ADDENDUM No. 2
Additions and Renovations
To the
Wilbraham Main Fire Station
For the
Town of Wilbraham, MA

Tecton Project No. WBR01.AR
February 10, 2012

This Addendum forms a part of the Construction Documents and modifies the original bidding documents dated January 19, 2012.

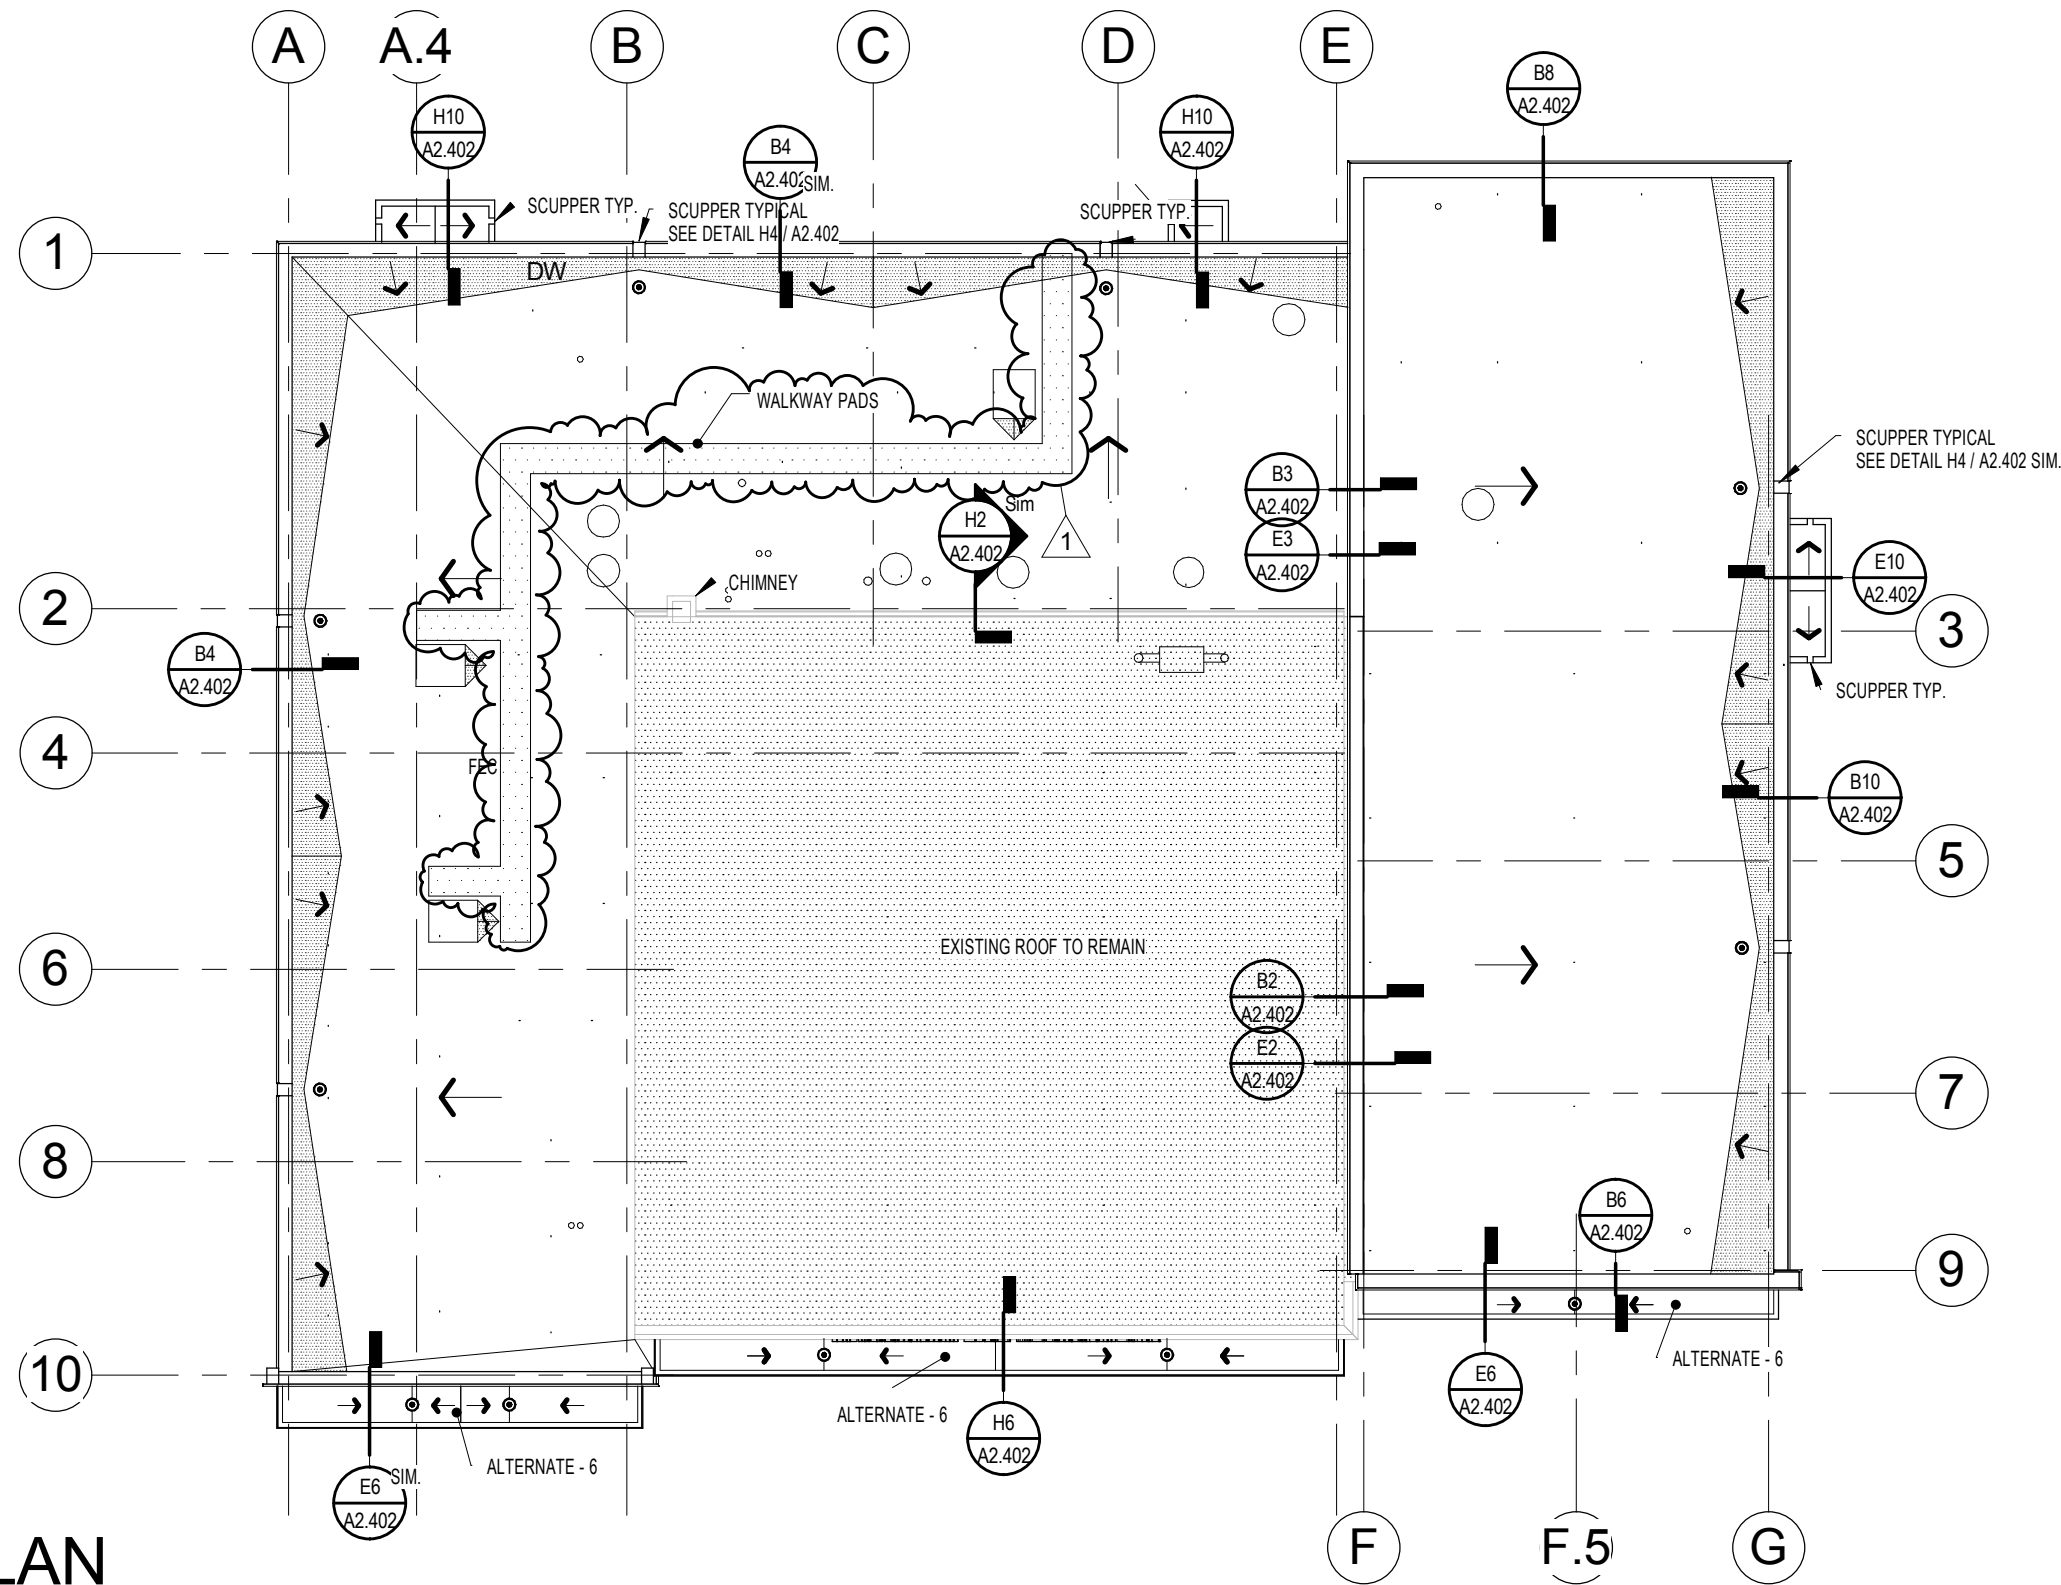
Add: walkway pads as shown on attached SKA-1

Drawing Title:
FLOOR PLAN - BASE BID

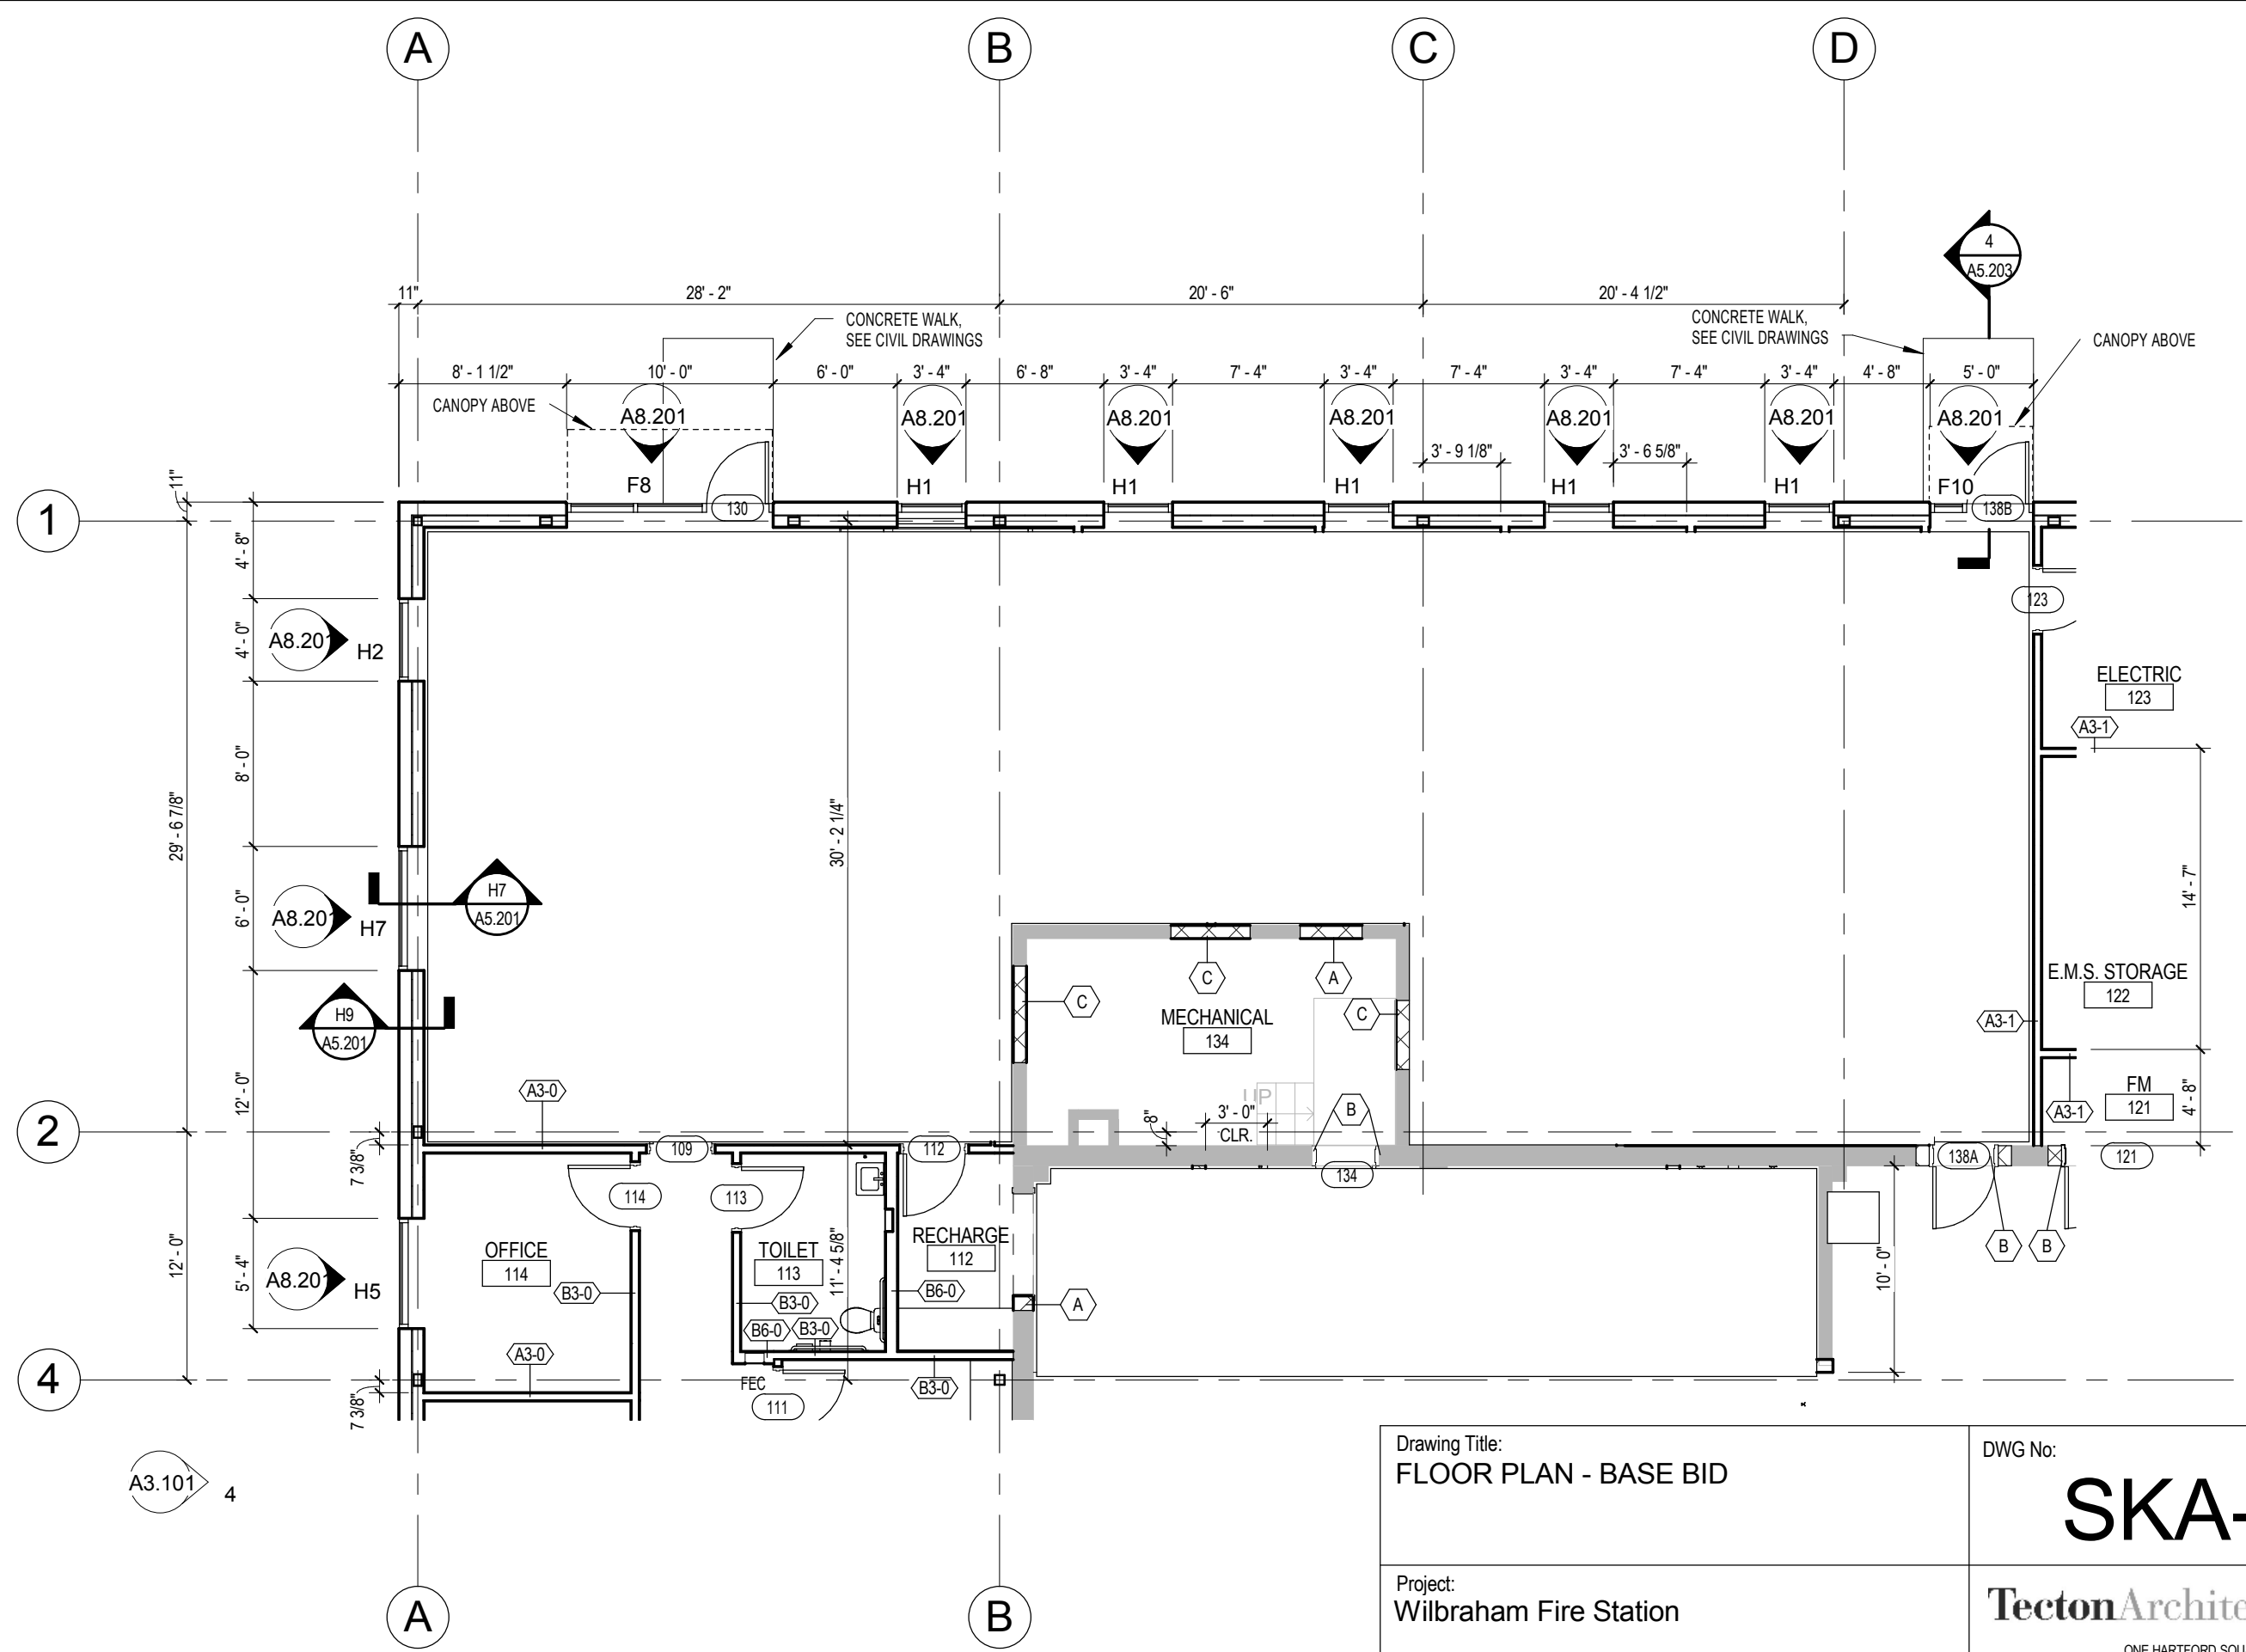
Clarification: Paragraph 3.1.A refer to SKA-2 Floor Plan – Base Bid which is provided solely to clarify the base bid partition configuration.

Drawing Title: HOLLOW METAL WINDOW FRAME	DWG No: <h1>SKA-3</h1>	Date: 02/09/12
		Scale: As indicated
Project: Wilbraham Fire Station 2770 Boston Road Wilbraham, MA	TectonArchitects inc ONE HARTFORD SQUARE WEST HARTFORD CONNECTICUT TEL: 860-548-0802 FAX: 860-249-2531	Job No: WBR-01-AR
		Revised:

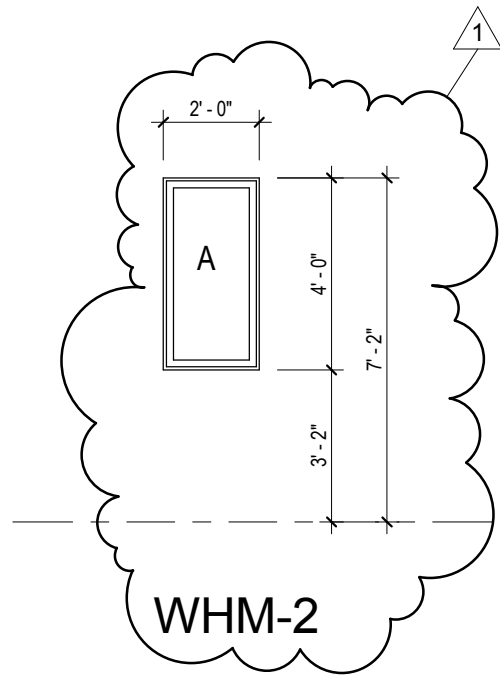
Add: Hollow metal windows as shown on SKA-3

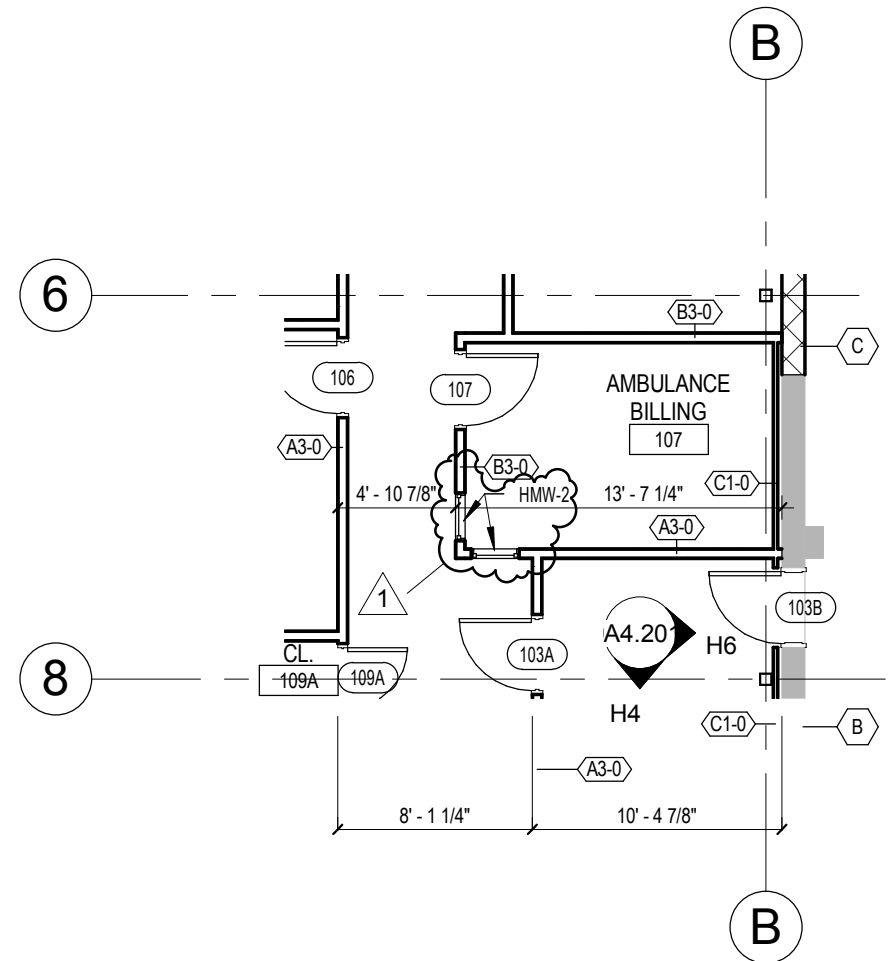
Clarification: Incorporate the clarifications and/or revisions on the following sketches: SK-P2 thru SK-P4.

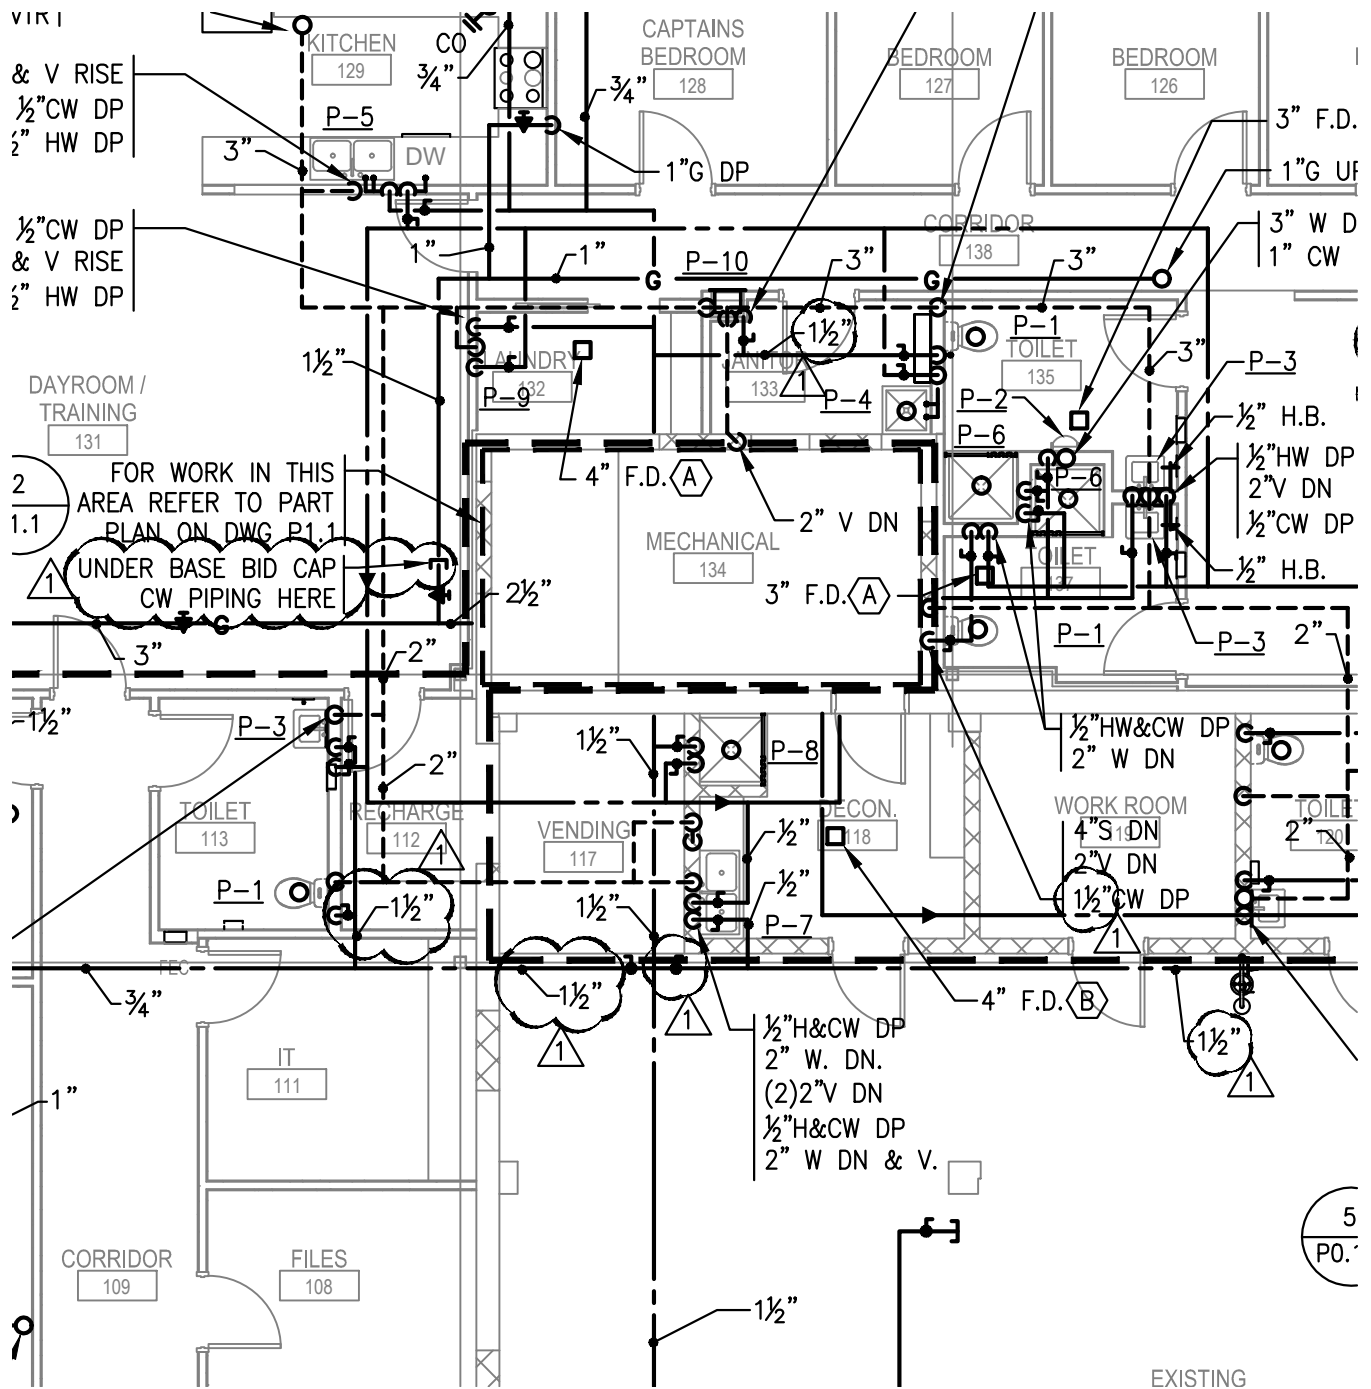
UNDER BASE BID CONTRACTOR
TO INSTALL HOT WATER LOOP
& CAP RUNOUTS TO FUTURE
FIXTURES
